**Proposal for Amendment 2 to UN GTR No. 9
(Pedestrian safety)**

Submitted by the Working Party on Passive Safety*

Amendment 2 to UN GTR No. 9 (Pedestrian Safety)

Figure 27
Flexible lower legform impactor: Test set-up for the dynamic lower legform impactor certification test (pendulum test, see paragraph 8.1.2.4.)

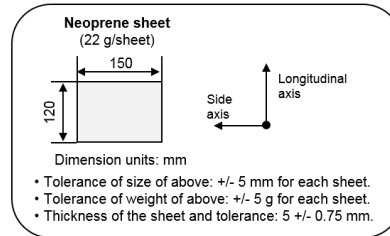
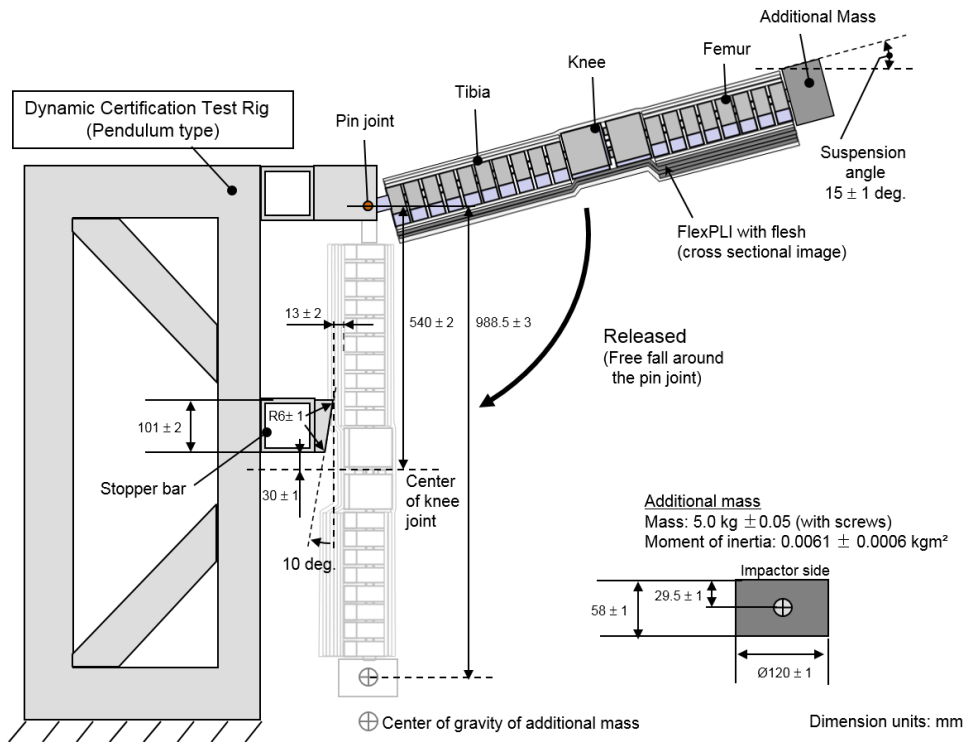
- 8.1.2.4. Test procedure
 - 8.1.2.4.1. The flexible lower legform impactor, including the flesh and skin, shall be suspended from the dynamic certification test rig $15 \pm 1^\circ$ upward from the horizontal as shown in Figure 27. The impactor shall be released from the suspended position and fall freely against the pin joint of the test rig as shown in Figure 27.

- 8.1.2.4.2. The knee joint centre of the impactor shall be $30 \pm 1 \text{ mm}$ below the bottom line of the stopper bar, and the tibia impact face without the flesh and skin shall be located $13 \pm 2 \text{ mm}$ from the front upper edge of the stopper bar when the impactor is hanging freely as shown in Figure 27. "

Figure 28
Flexible lower legform impactor: Test set-up for the dynamic lower legform impactor certification test (inverse test, see paragraph 8.1.3.4.)

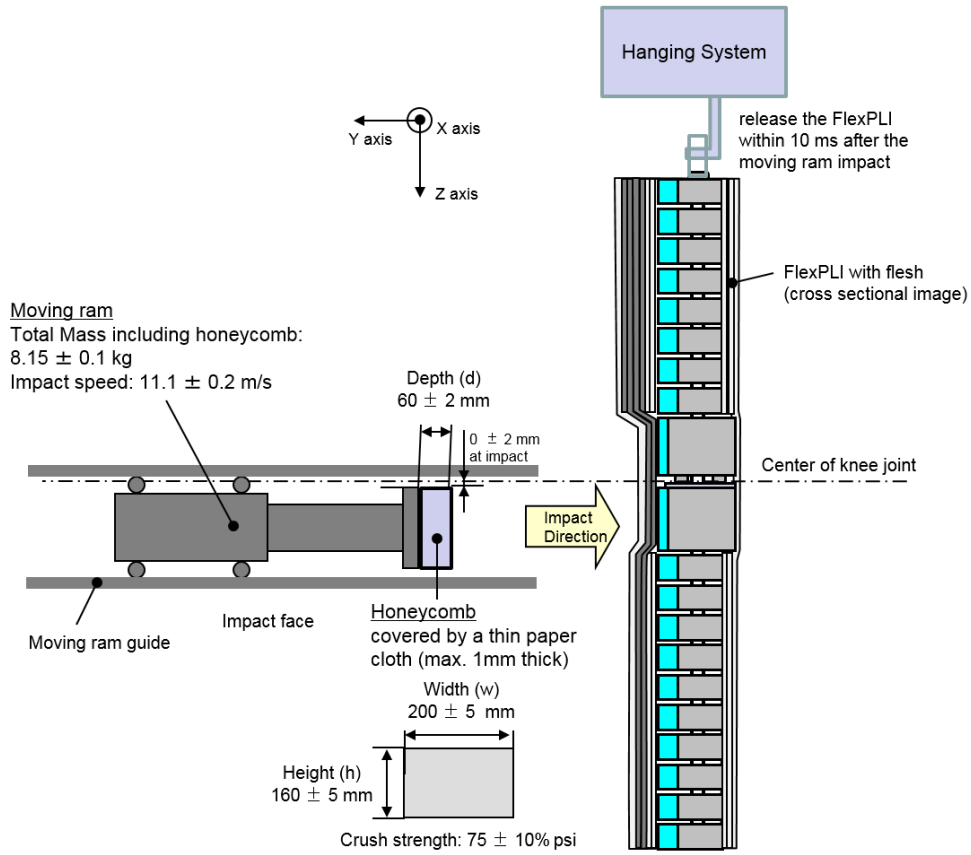
8.1.3.4.1. The assembled flexible lower legform impactor (with the flesh and skin) shall be hung vertically and freely suspended from a test rig as shown in Figure 28. It is then impacted by the upper edge of a linearly guided aluminium honeycomb impactor, covered by a thin paper cloth with a maximum thickness of 1 mm, at an impact speed of $11.1 \pm 0.2 \text{ m/s}$. The legform shall achieve a free flight condition within 10 ms after the time of first contact of the honeycomb impactor.

8.1.3.4.4. At the time of the first contact, the flexible lower legform impactor pitch angle (rotation around the Y-axis) and, therefore, the pitch angle of the velocity vector of the honeycomb impactor shall be within a tolerance of $\pm 2^\circ$ in relation to the lateral vertical plane. The flexible lower legform impactor roll angle (rotation around the X-axis) and, therefore, the roll angle of the honeycomb impactor shall be within a tolerance of $\pm 2^\circ$ in relation to the longitudinal vertical plane. The flexible lower legform impactor yaw angle (rotation around the Z-axis) and, therefore, the yaw angle of the velocity vector of the honeycomb impactor shall be within a tolerance of $\pm 2^\circ$.
